**2.0 Geology and Topography, Comments and Responses**

### **2.3 Comments on the DEIS and Responses to Comments**

SITE PHASING PLAN and  
 TRUCK ROUTING DIAGRAM  
**COURTYARD AT  
 UPPER NYACK**  
 VILLAGE OF UPPER NYACK  
 ROCKLAND COUNTY, NEW YORK  
 JULY 20, 2005  
 SCALE: 1 IN.= 100 FT.

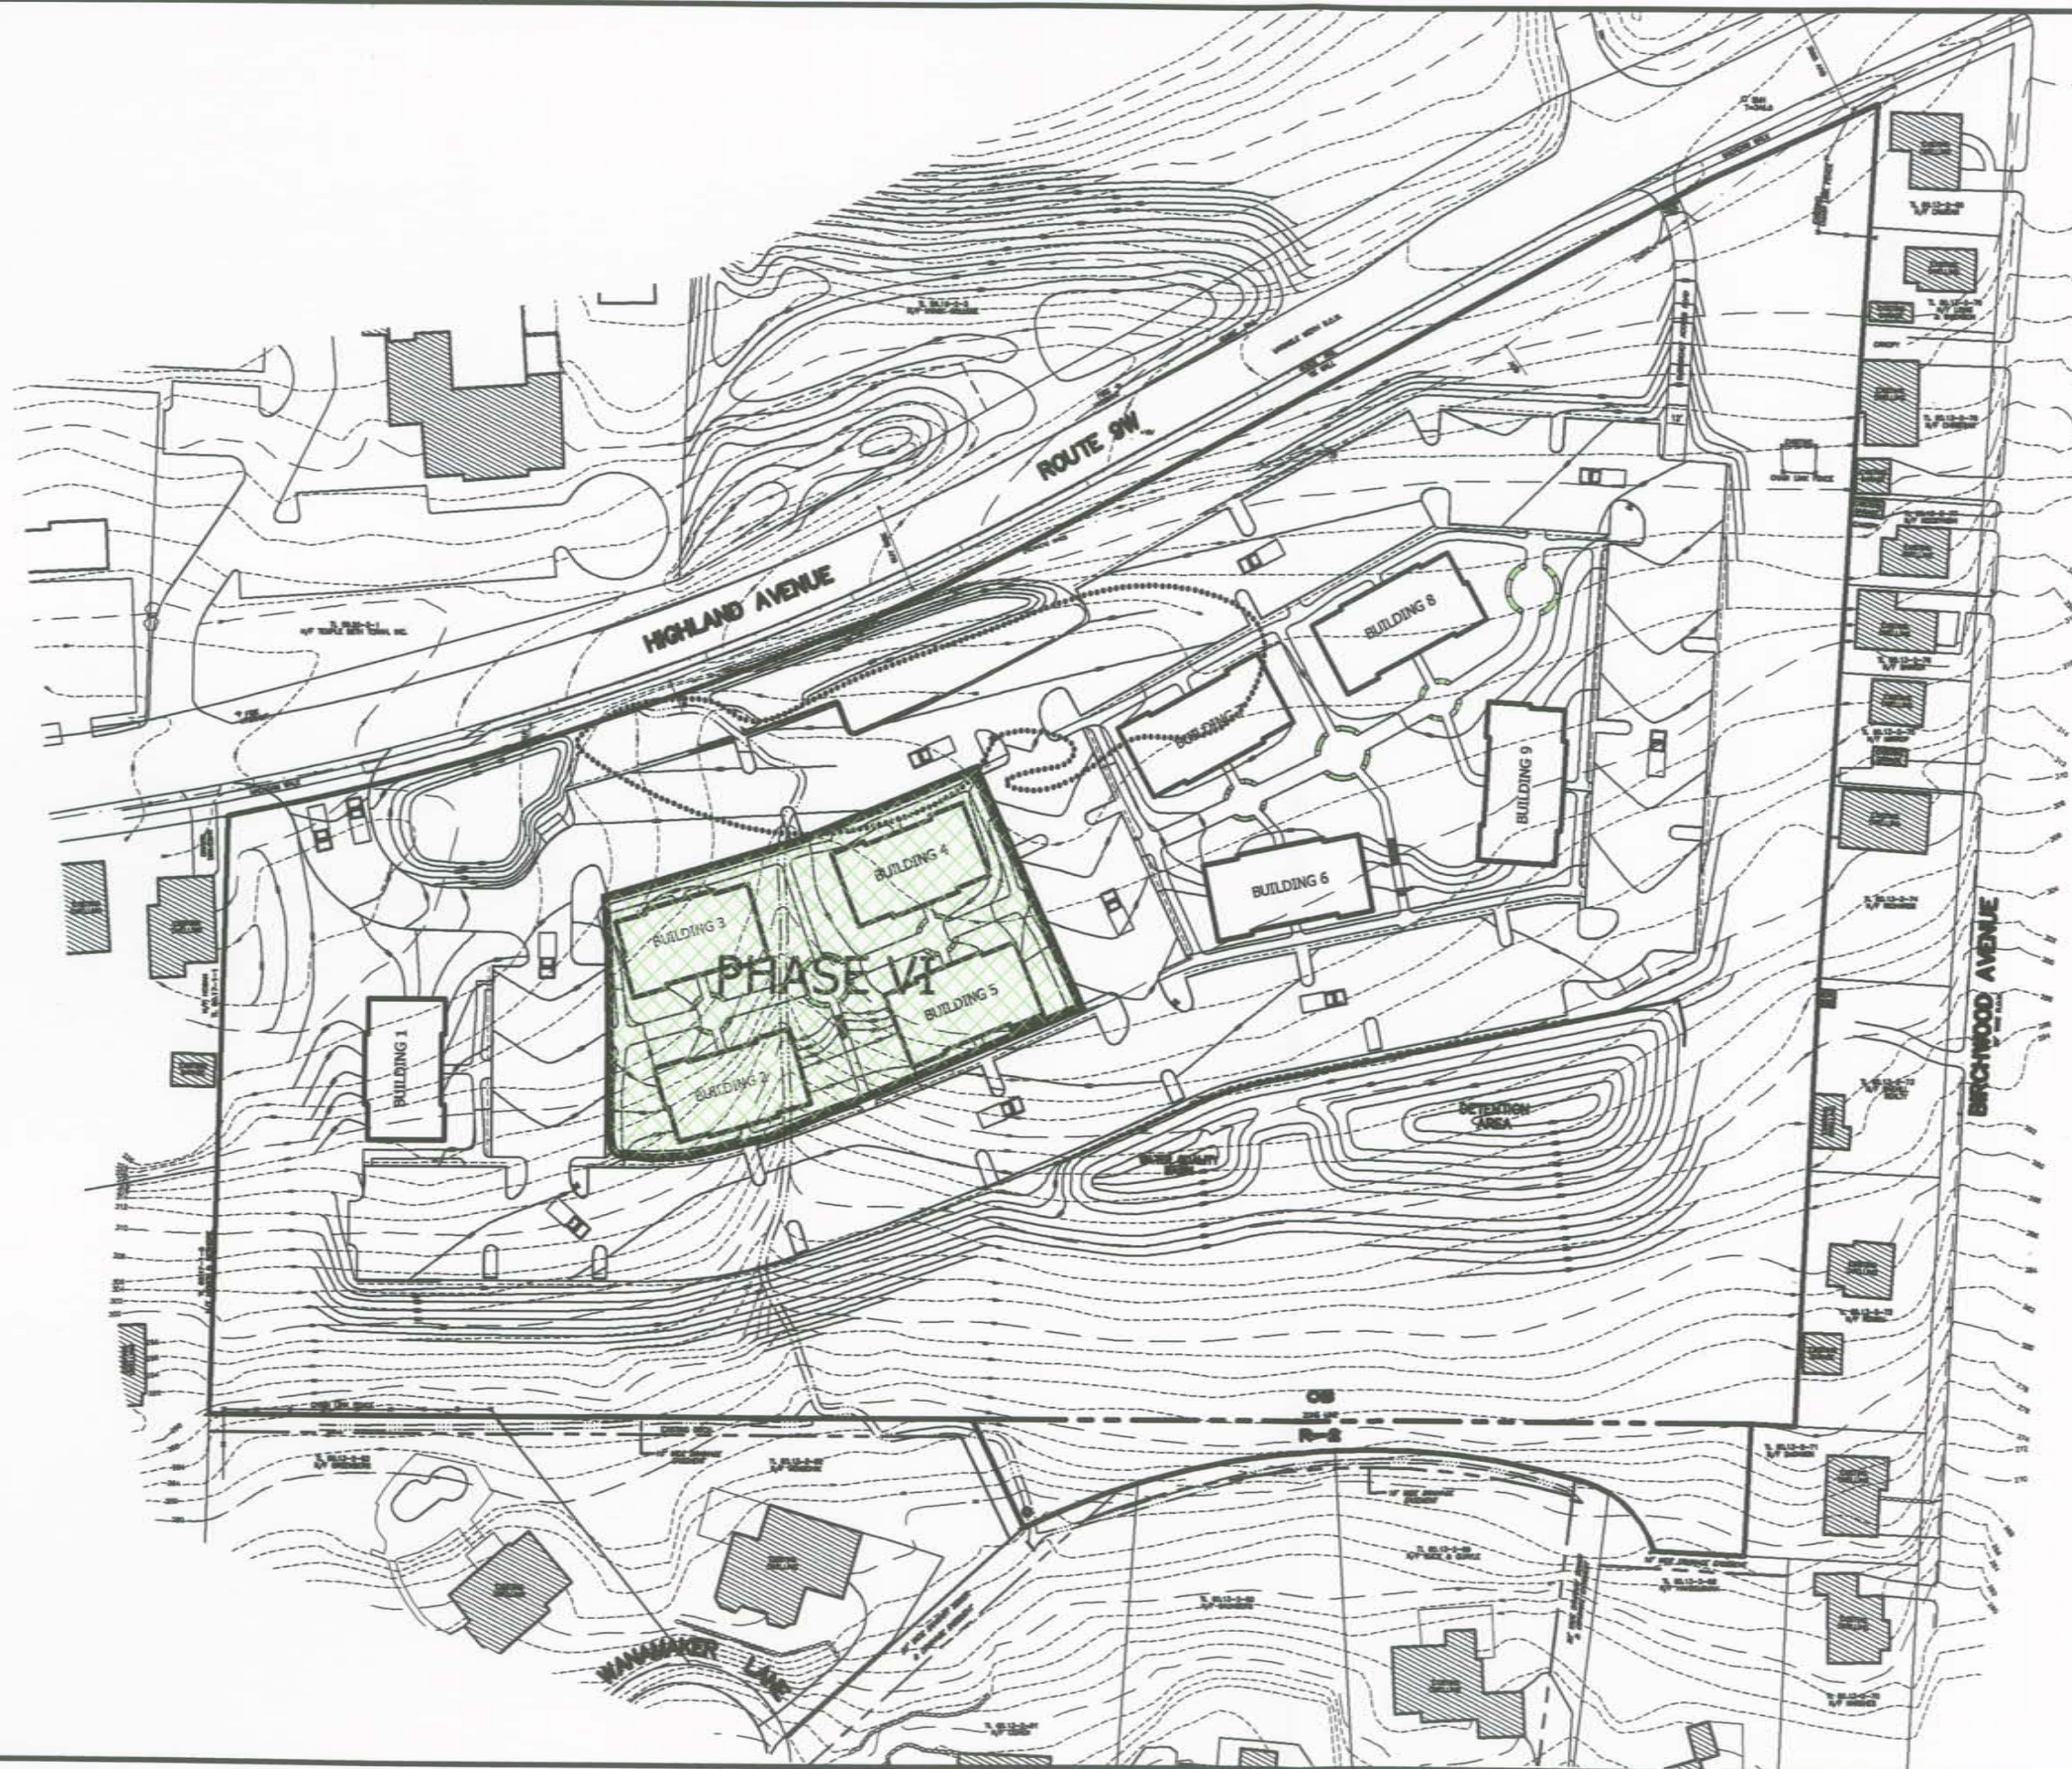
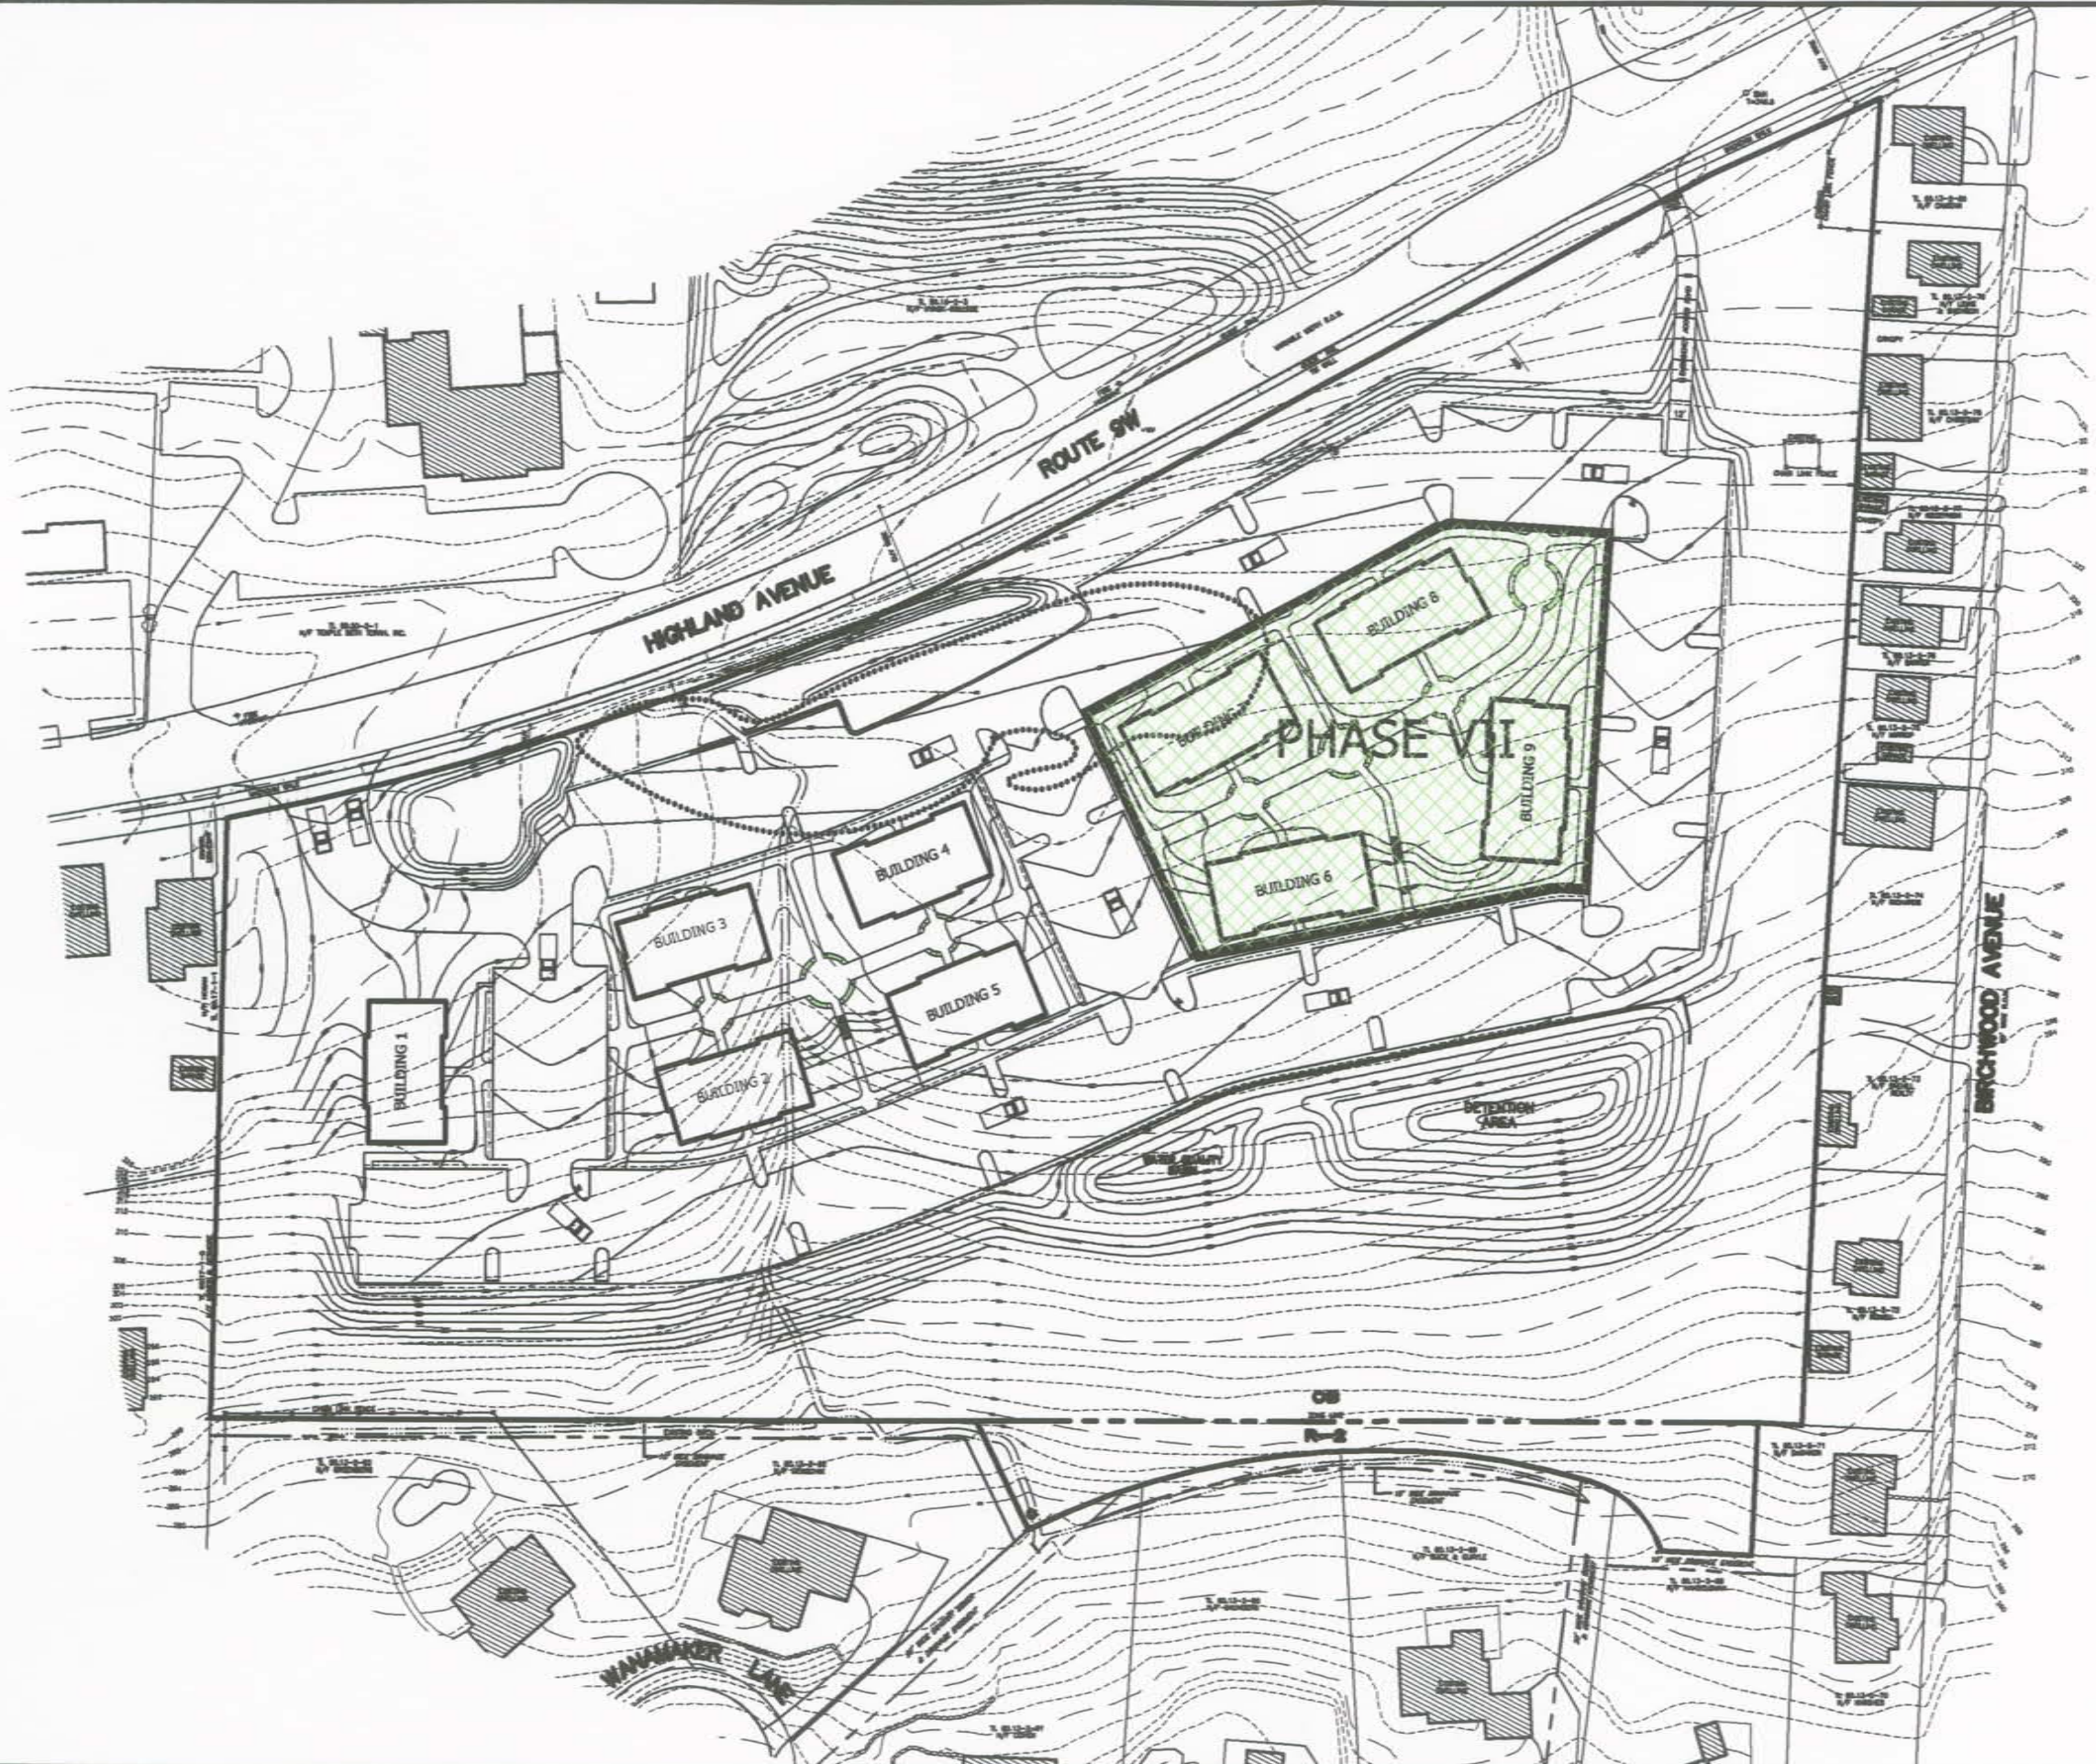
**Comment 2-9 (Letter #22, Robert Geneslaw, Robert Geneslaw Co., 2/1/05):** Section 3.1.2 Potential Impacts [of Land Resources]. Please provide a graphic representation of how 20-yard trucks would enter and exit the site, and where waiting areas would be for the truck for loading.

***Response 2-9: Commercial Nine Building Plan*** - *The project engineer prepared figures titled "Site Phasing Plan and Truck Routing Diagram" which shows the requested information. These figures are provided at the end of this section.*

***Residential Subdivision Plan*** - *For this alternative the site phasing plan will provide the requested information. Due to the significant reduction in truck traffic associated with the residential alternative, the locating of truck staging areas is not presumed to be a problem.*
